**RE: 2 DELMAR PARADE, DEE WHY – S4.55 APPLICATION  
RESPONSE TO COUNCIL COMMENTS**

As requested, please find herein The Transport Planning Partnership's (TPPP) response to the traffic related comments made by Northern Beaches Council (Council) for the above proposed development.

**Figure 1: Approved Layout**

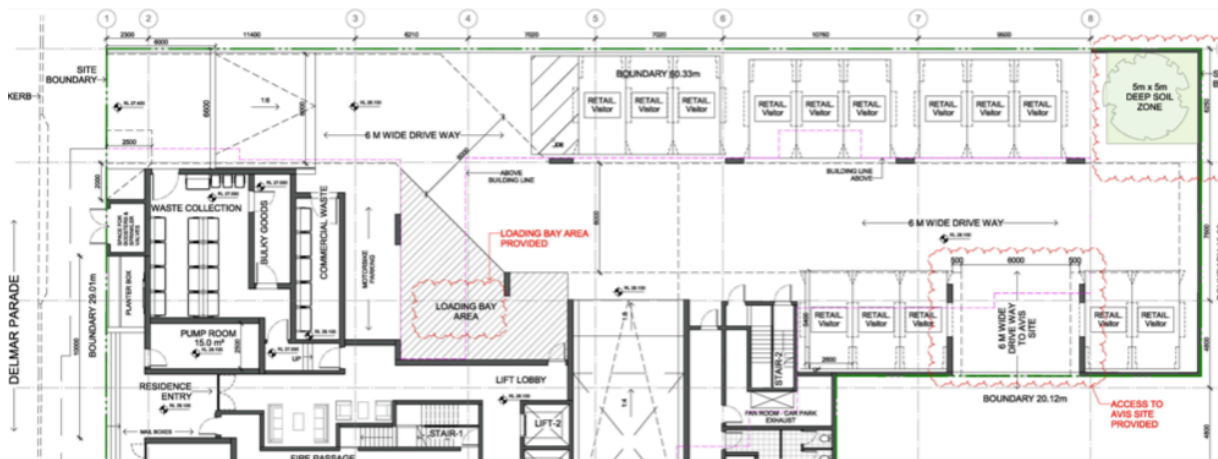
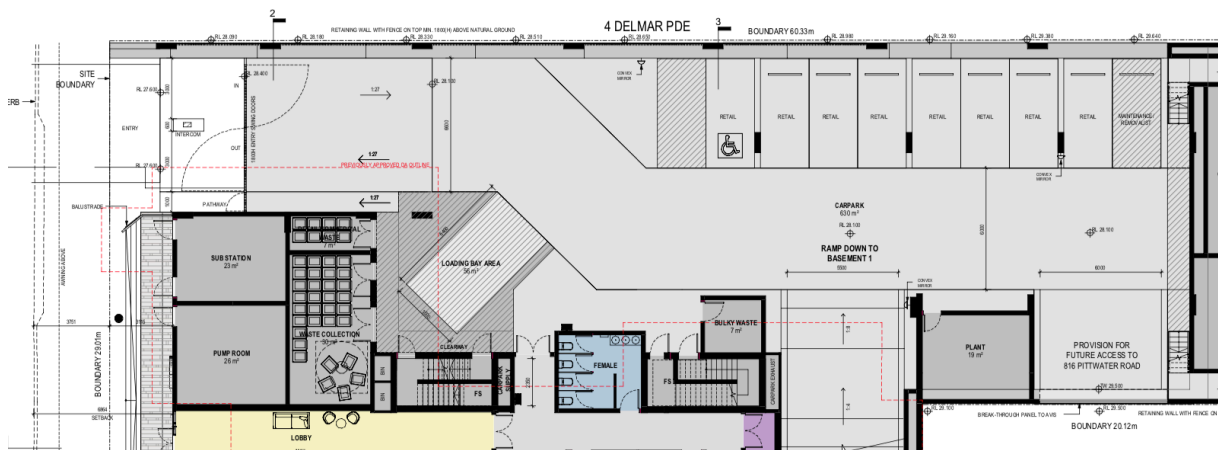
- two-way access at the access off Delmar Parade to ensure that there are no vehicle queues overflowing on to the road
- vehicular conflict at the sharp bend located between the access and the ramp down to basement one, and
- vehicular conflict at the ramps.

However, the car park layout and circulation arrangements have been maintained as per the approved development with:

- a 6.6m wide access off Delmar Parade
- a 6m wide right-of-way circulation aisle that is shared with 814-816 Pittwater Road
- a 6m wide ramp into 814-816 Pittwater Road
- a generally consistent car park layout in terms of circulation, and

- a loading bay for waste collection vehicles sized up to an SRV, which is located at a bend between the access and the ramp into basement one – albeit the angle of the loading bay has been revised to improve swept paths on entry.

On the above basis, the S4.55 application does not propose any modifications to the general layout and circulation arrangements of the site.

TITLE: 6.4m SMALL RIGID VEHICLE & 5.2m B99 VEHICLE SWEEP PATH GROUND LEVEL

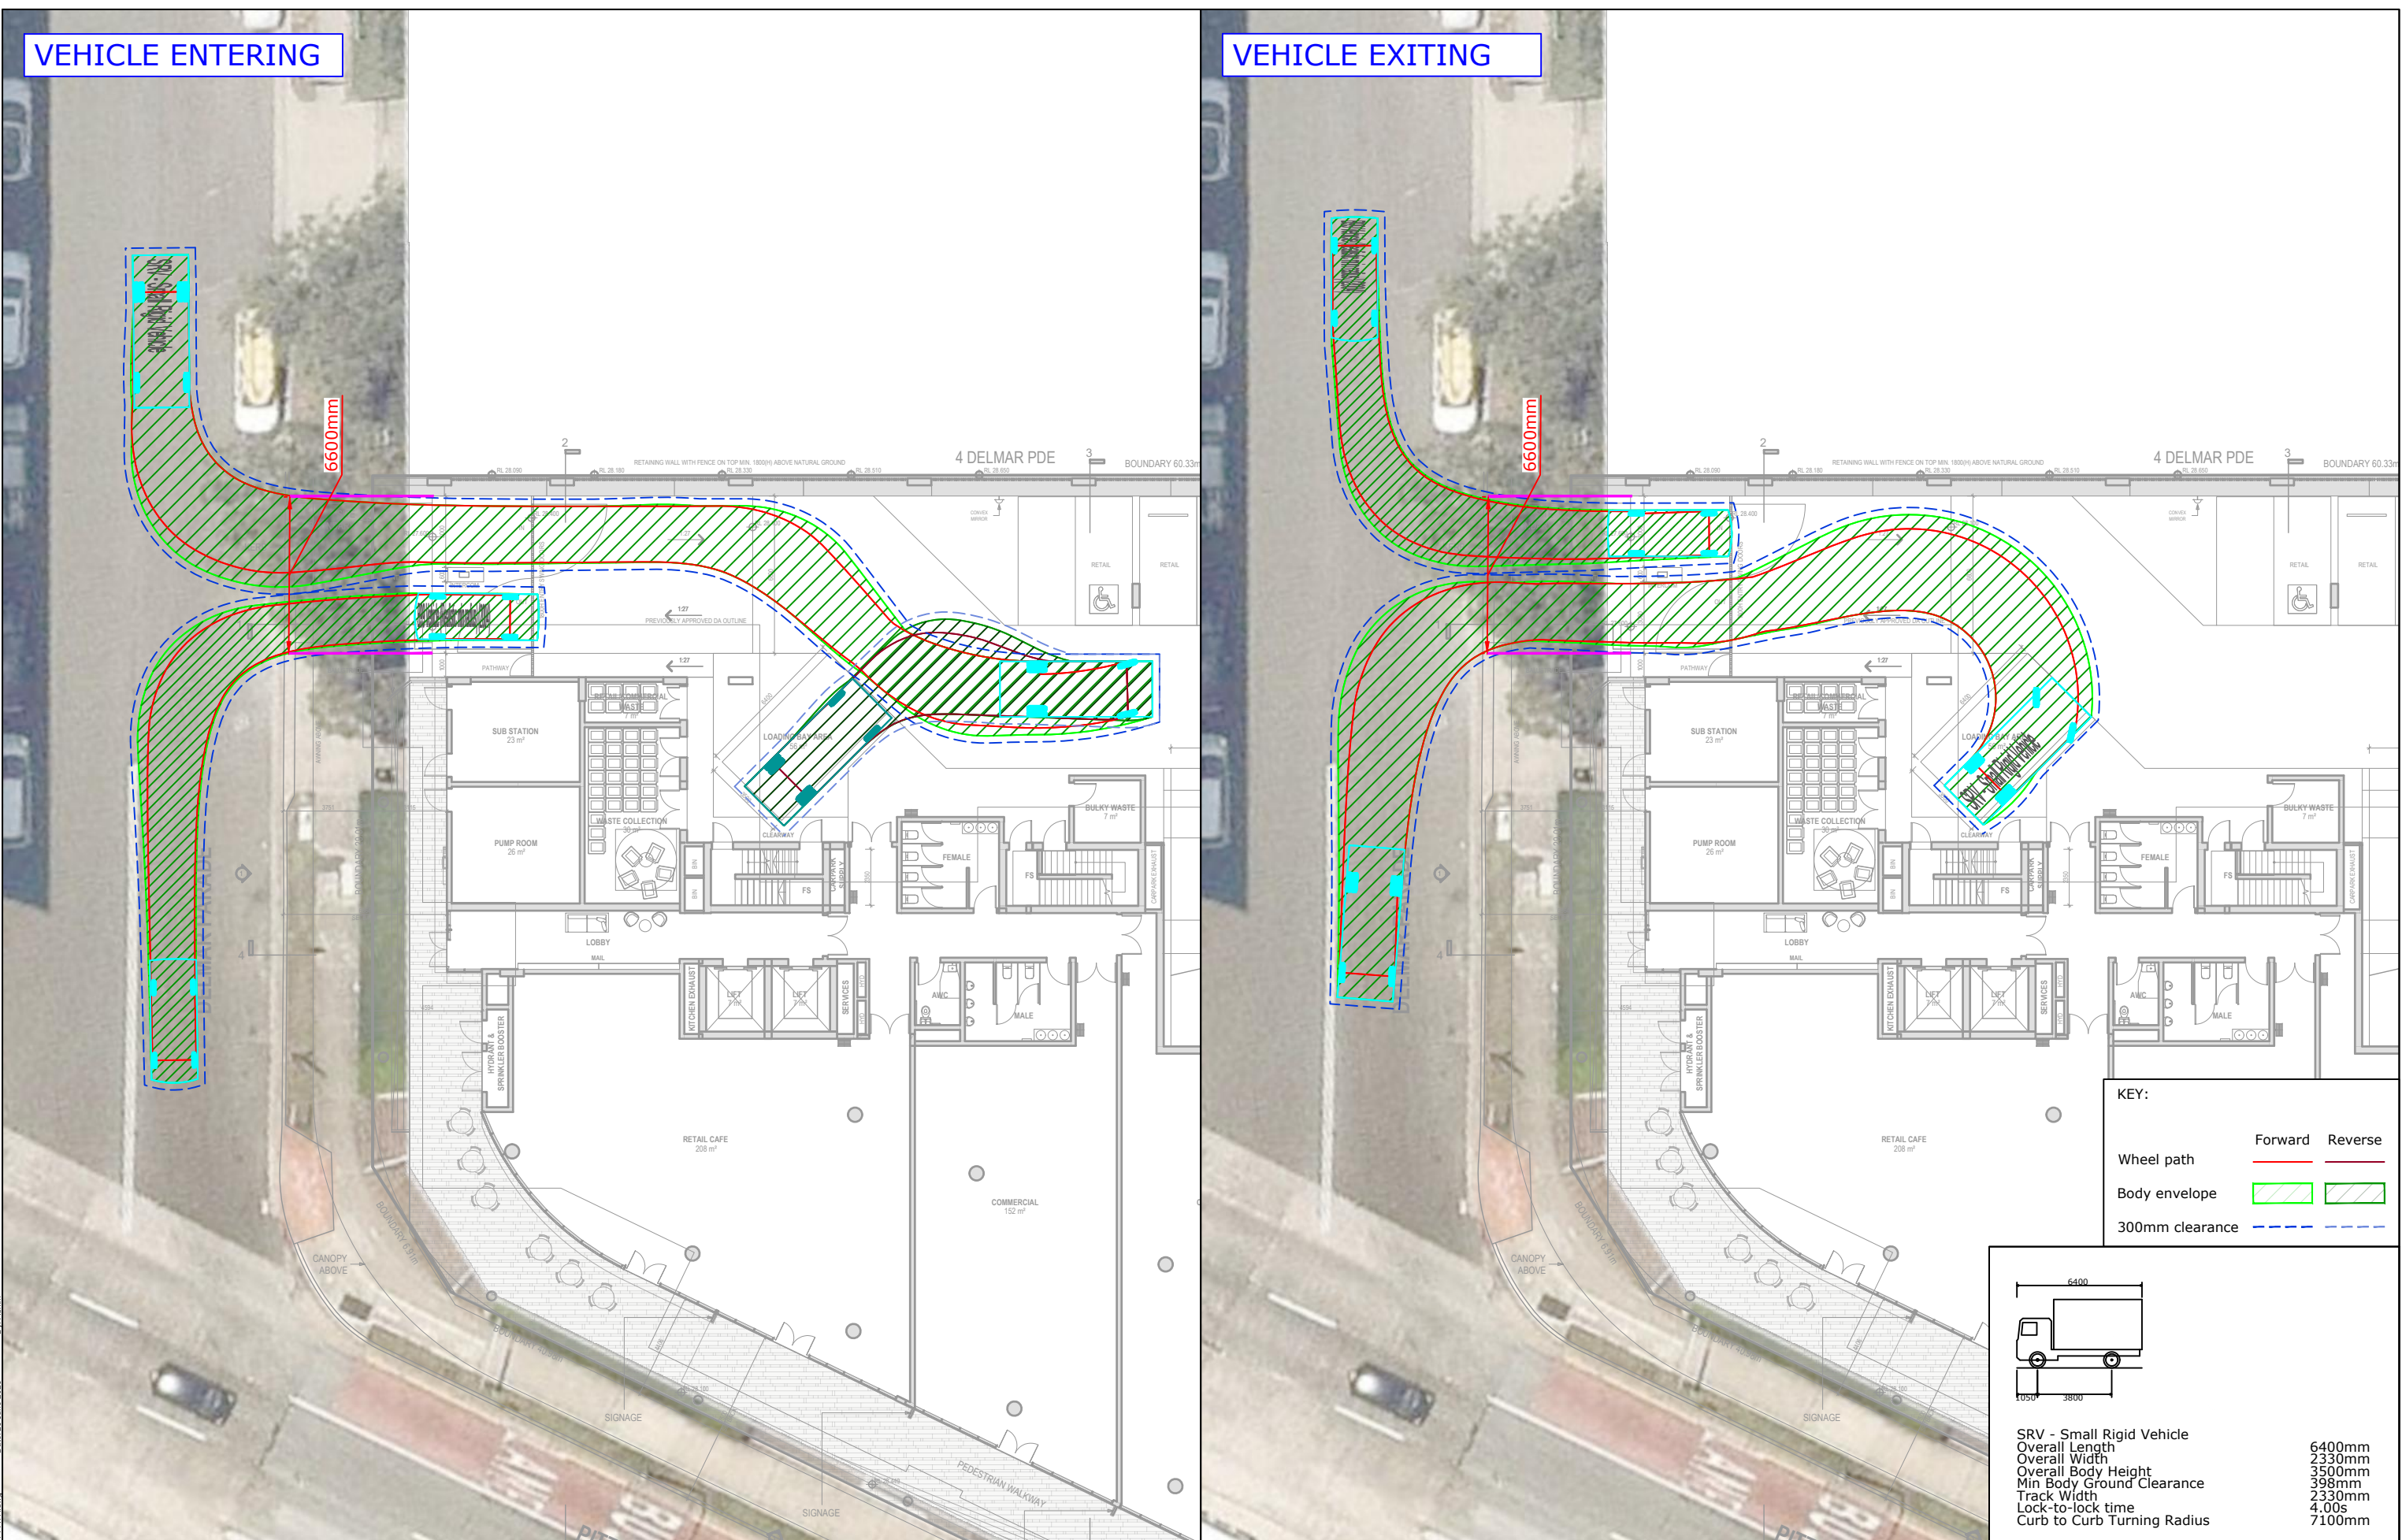
*"The access driveway is to accommodate simultaneous ingress and egress of the largest vehicle accessing the site and B99 vehicle to avoid any waiting and queuing on the street.*

Council has also raised concerns regarding two-way flows and the potential for vehicle queues to overflow on to the road. TPPP's swept path analysis, as provided Attachment Three, indicates that the driveway off Delmar Parade will permit two-way flows between the largest vehicle, a SRV and a B99 car.

Additionally, the security line (garage door) is located within 6.6m from the property boundary which is compliant with Australian Standards and is sufficient for one vehicle to queue in front of the garage door, without encroaching the footpath or the roadway.

TITLE: B99 VEHICLE SWEEP PATH GROUND LEVEL

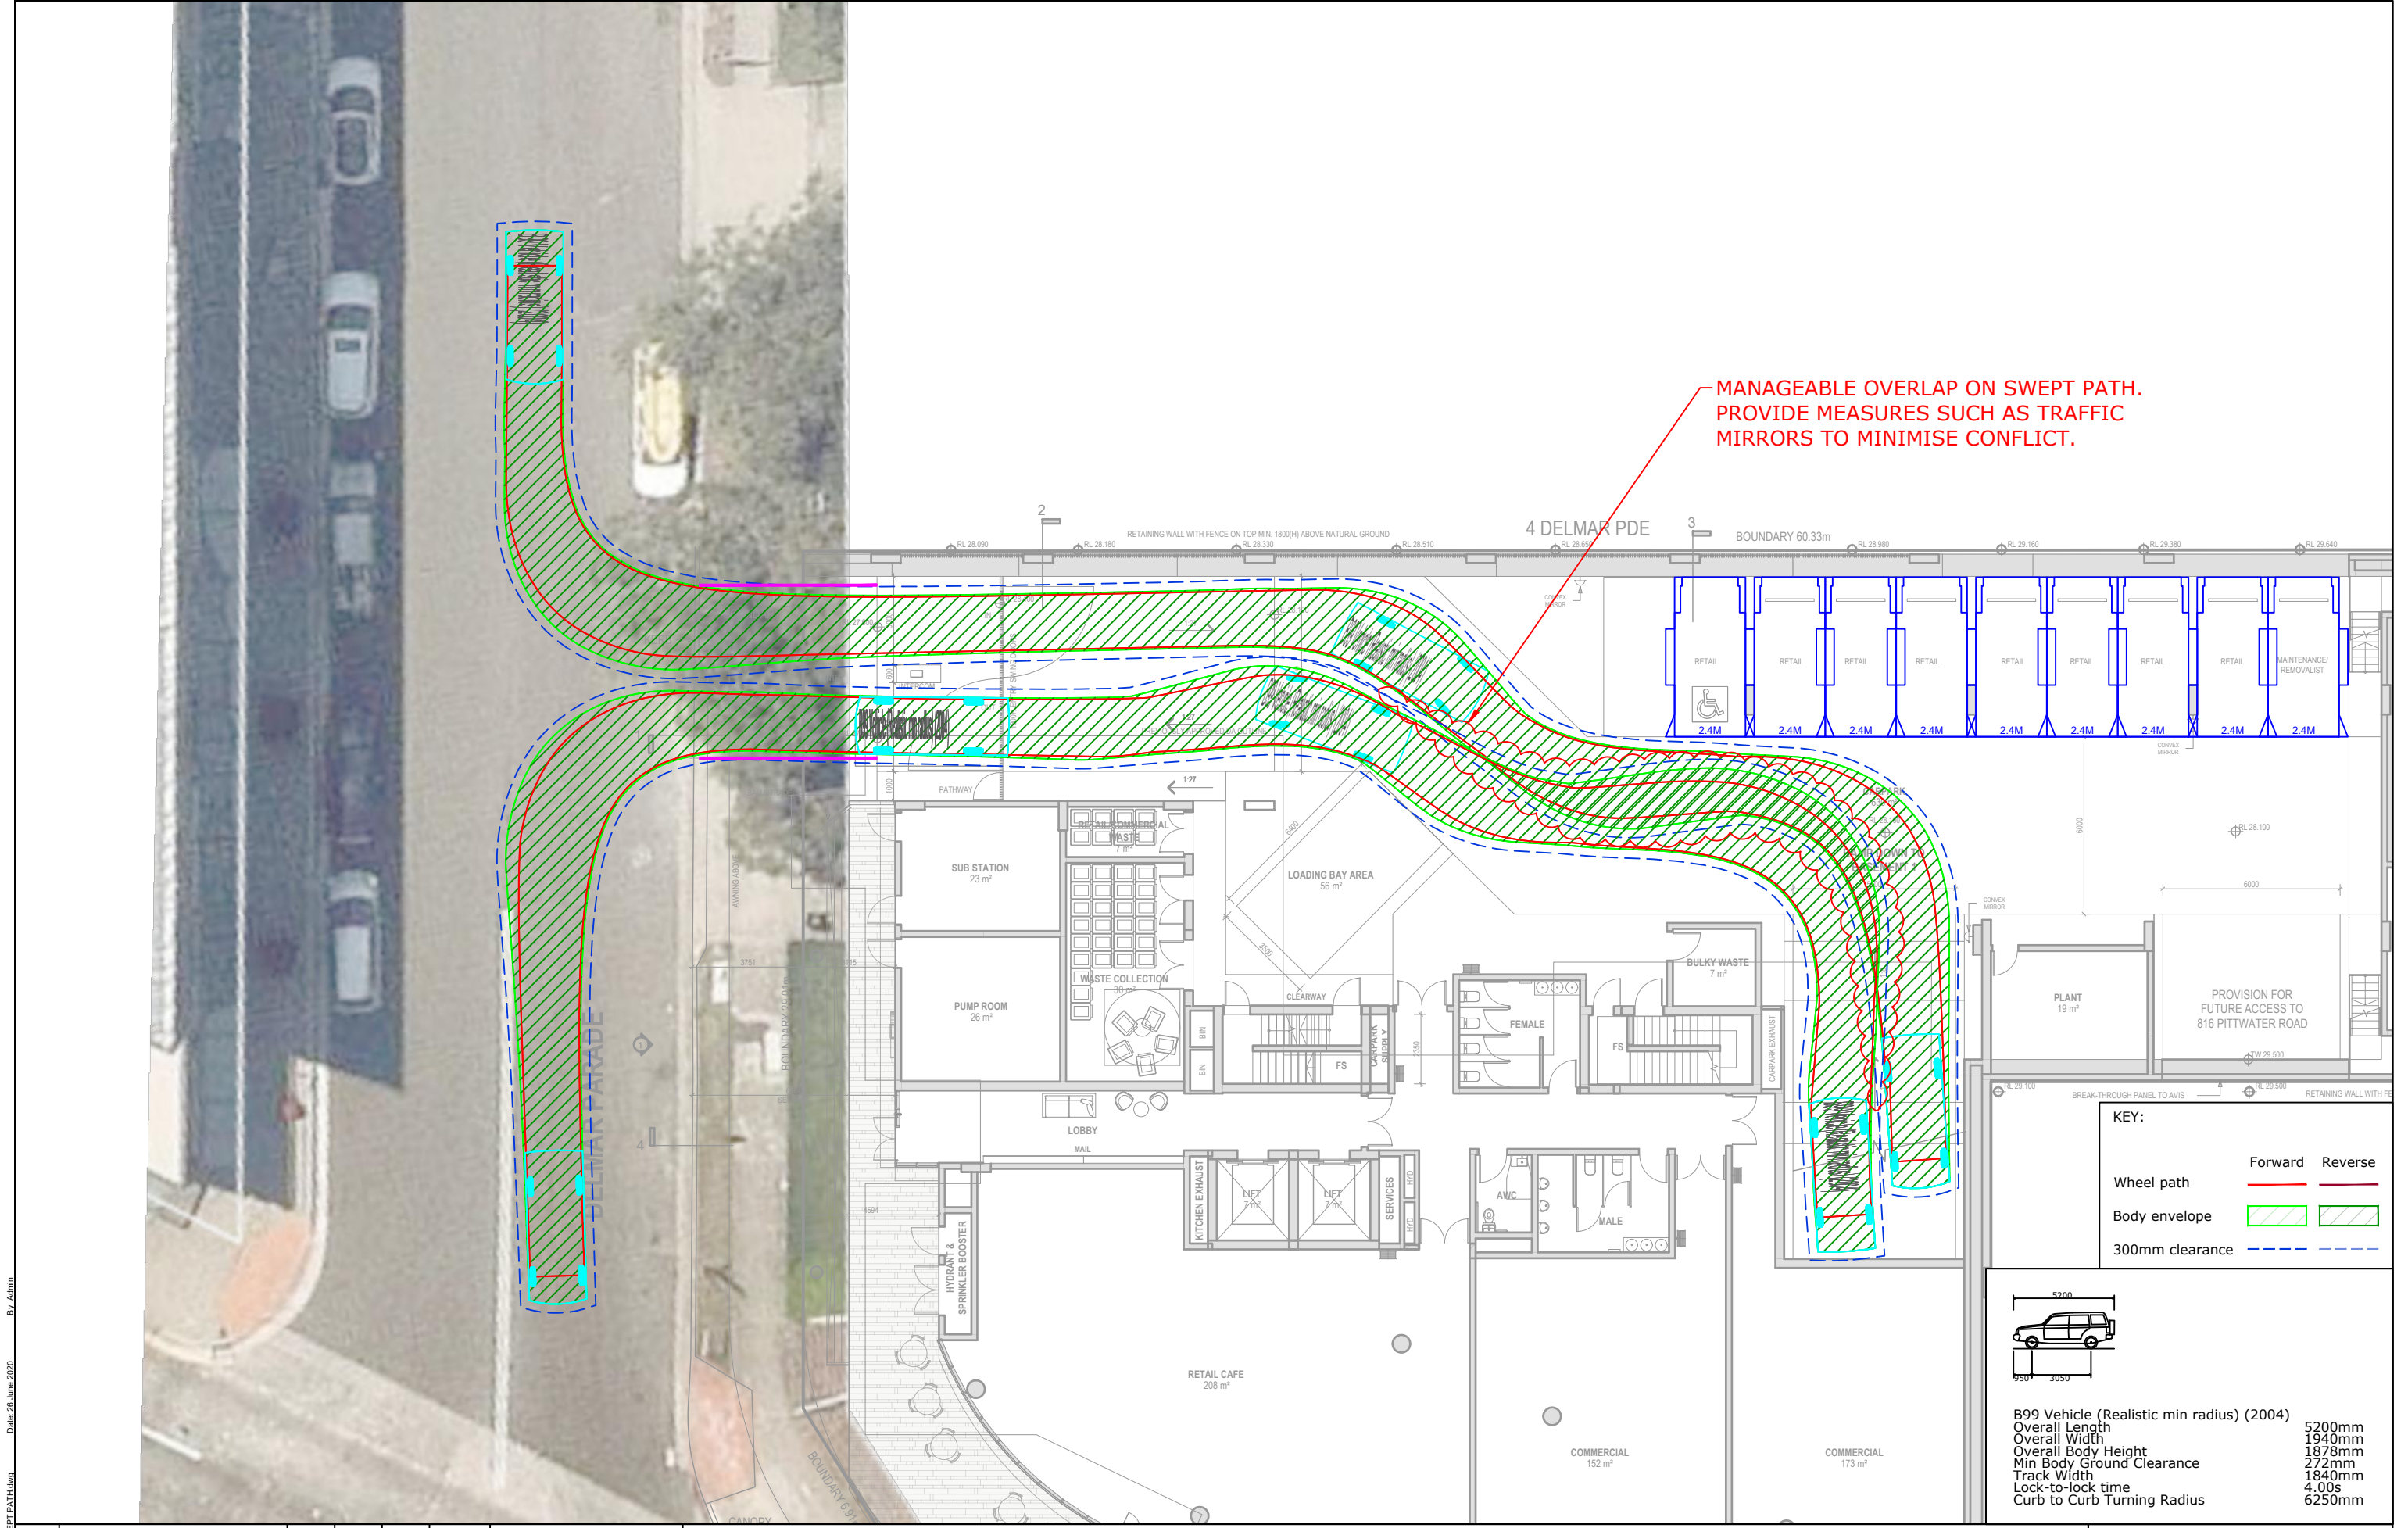
The swept paths in Attachment Three indicate that there is conflict with two-way flows between B99 vehicles at bends and intersections. However, we note that it is not uncommon for car parks designed to Australian Standards, to have conflicts at bends and corners, with the theoretical swept paths being generally conservative.

Nonetheless, it is considered that two-way flows at these conflict points should be managed with the provision of appropriate traffic management measures, such as convex mirrors to improve sight distance at the following locations:

- between the site access and the loading bay
- between the basement one ramp and loading bay
- between the aisle and access into 814-816 Pittwater Road.

MANAGEABLE OVERLAP ON SWEEP PATH.  
 PROVIDE MEASURES SUCH AS TRAFFIC  
 MIRRORS TO MINIMISE CONFLICT.
